## ***Interactive comment on “Drought monitoring and prediction in climate vulnerable Pakistan: Integrating hydrologic and meteorologic perspectives” by Taimoor Akhtar et al.***

**Taimoor Akhtar et al.**

Received and published: 1 April 2021

**Fig. 1.** Comparison of monthly CRU precipitation with station observations.

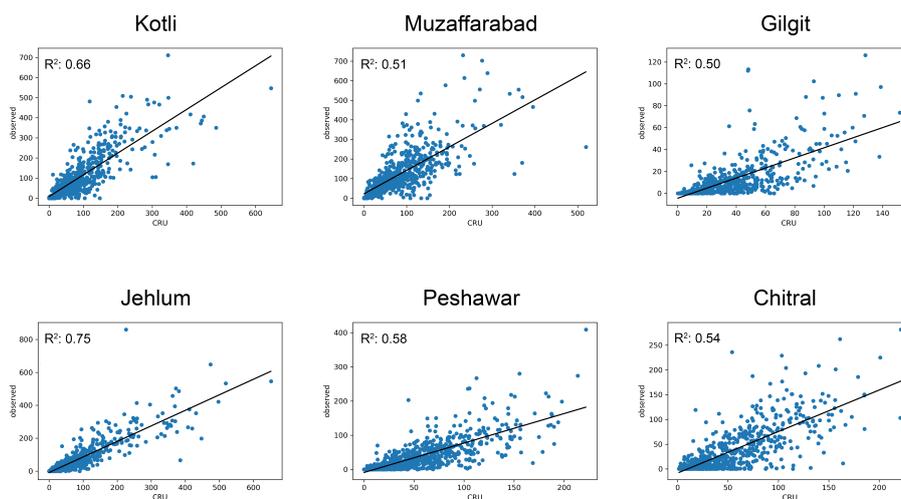
- Line 83: In order to claim and highlight that gridded climate datasets can be a reasonable alternative to station data for drought analysis in catchments under study, referring to other studies is not enough. At least, uncertainty of several gridded data must be investigated and communicated and a comparison between existing station and gridded data be investigated based on existing literature.

Response: We agree that referring to other studies is not enough to ascertain the accuracy of a chose dataset. Thus, we have computed correlations between CRU TS4.3 and observed precipitation (mm) of six stations within the study area (4 catchments),

and results are provided in the attached Figure 1. The stations analyzed and corresponding catchments (mentioned within brackets) to which they belong to are: Jhelum (Jhelum), Peshawar (Kabul), Chitral (Kabul), Gilgit (Indus), Kotli (Jhelum) and Muzafarabad (Jhelum). These stations are maintained by Pakistan Meteorological Department (PMD). In Figure 1, observed precipitation (mm) are compared to corresponding values of nearest grid point available in the CRU data sets, with R squared values ranging from 0.5-0.75. We will include these comparisons in the revised manuscript as well, and will also include more stations, if available. Moreover, we will also include APHRODITE precipitation in the comparative analysis, and use the precipitation product for SPEI calculations, that better correlates with station observations.

**Fig. 2.** Heatmap of cross-correlations between SSI-1 and SPEI (for different accumulation periods) for the four Upper Indus catchments, i.e., Chenab, Jhelum, Indus and Kabul.

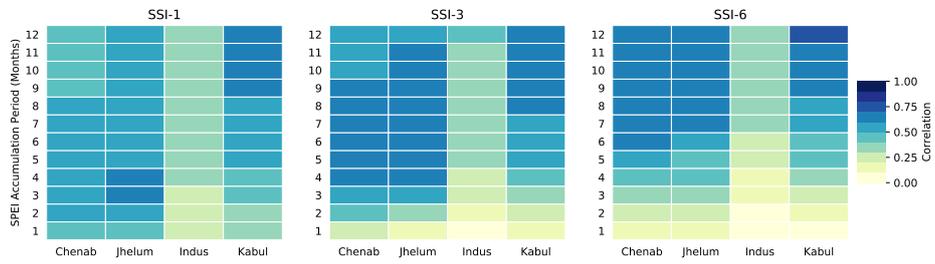
- Figure 8: Please specify if the figure is based on areal-average of all four catchments and provide the same heat-map based on SSI-3 and SSI-6.

Response: The figure is based on computation of SPEI on the entire catchment after aggregating of climate variables across all grid cells. A figure that includes SSI-3 and SSI-6 is attached as Figure 2 of this response.
